DEVELOPMENT ASSESSMENT PANEL REPORT

Application No.	DA/2024/0004
Address	45 Bradford Street BALMAIN
Proposal	Alterations and additions to dwelling including new attic bedroom.
Date of Lodgement	11 January 2024
Applicant	Mr Christopher Brookes
Owner	Mr Gregory J Cameron Ms Lesley F Kennedy
Number of Submissions	1
Cost of works	\$260,000.00
Reason for determination at Planning Panel	Section 4.6 variation exceeds 10%
Main Issues	<ul style="list-style-type: none"> • Matters pertaining to heritage conservation • Section 4.6 Exception to Floor Space Ratio Development Standards
Recommendation	Approved with Conditions
Attachment A	Recommended conditions of consent
Attachment B	Plans of proposed development
Attachment C	Section 4.6 Exception to Development Standards
Attachment D	Statement of Heritage Significance

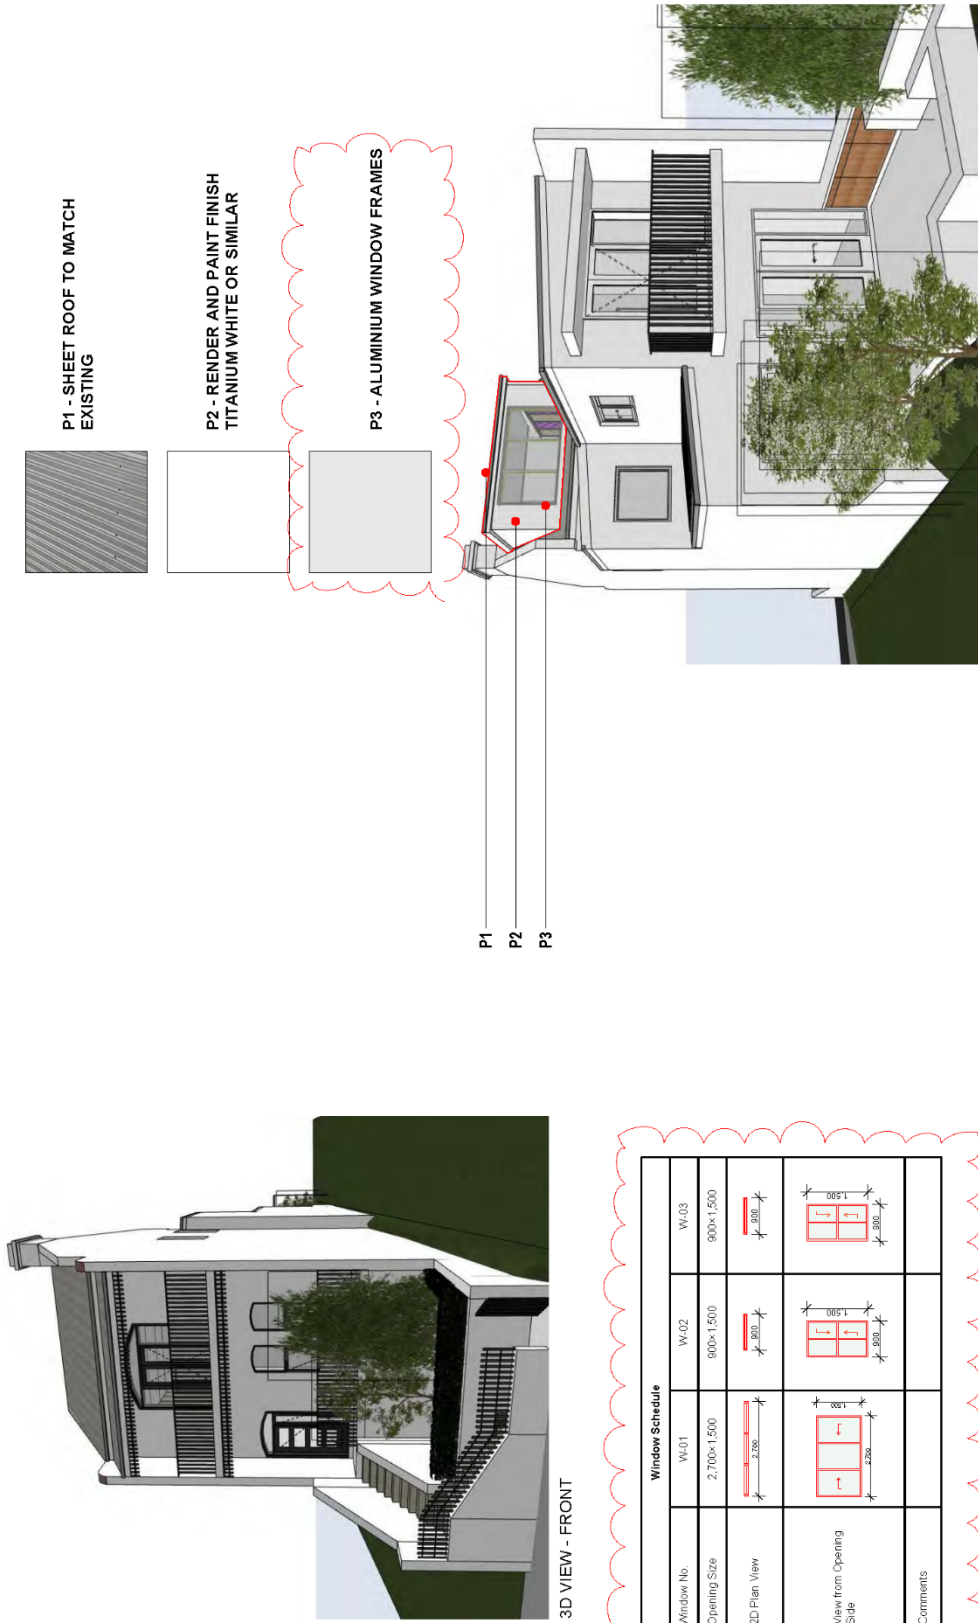
The submitted Finish Schedule and Window Schedule, prepared by Brookes Associates Architects and dated 21/03/2024, specifies “sheet roof to match existing” for the proposed skillion dormer, with the Roof Plan and Elevations showing the existing roof material of the main dwelling as corrugated sheeting. However, a site inspection conducted on 21/03/2024 noted the existing roof material to be Welsh slate tiles. As such, it is recommended a condition be imposed to retain and repair (where needed) the existing slate tiles to the main gable roof form to ensure appropriate materials are maintained in the Gladstone Park Distinctive Neighbourhood.

As discussed above, the horizontally proportioned window (W-01) and external louvres located on the proposed dormer are considered to be unsympathetic to existing windows within the elevation of the Victorian terrace building type. As such, it is recommended a condition be imposed to amend the proposed openings to vertically proportioned windows and remove the proposed louvres to maintain their presentation to the public domain.

7.	<p>Design Change</p> <p>Prior to the issue of a Construction Certificate, the Certifying Authority must be provided with amended plans demonstrating the following:</p> <ul style="list-style-type: none"> a. The horizontally proportioned window (W-01) and external louvres located on the northwest elevation at attic level are to be deleted and replaced with vertically proportioned windows employing a traditional design (timber sash) and materials (timber frame). b. The existing Welsh slate roof tiles to the main gable roof form are to be retained and repaired where required. <p>Reason: To preserve the environmental heritage of the Inner West</p>
